Service Bulletin

Bulletin No.: 22-NA-210

Subject: Broken Ground Stud on LM2 Light Duty Trucks

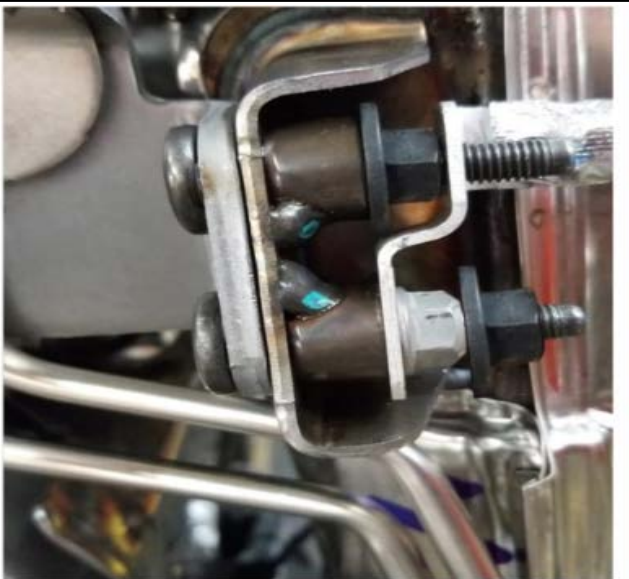
Involved Region or Country	North America		
Condition	Some technicians may find that the stud at the G134 location is broken.		
Cause	This condition may be caused by vibration fatigue.		
Correction	 <p style="text-align: right;">6340661</p> <p>Note: The graphic depicts the location of the ground and stud.</p> <ol style="list-style-type: none"> 1. Replace the NOx catalyst with the broken stud. Refer to the Service Procedure. 2. Install nut (P/N 11610091) and torque to 26 Nm (53 in lbs). 3. Install the ground strap. 4. Install second nut (P/N 11546441) and torque to 26 Nm (53 in lbs).
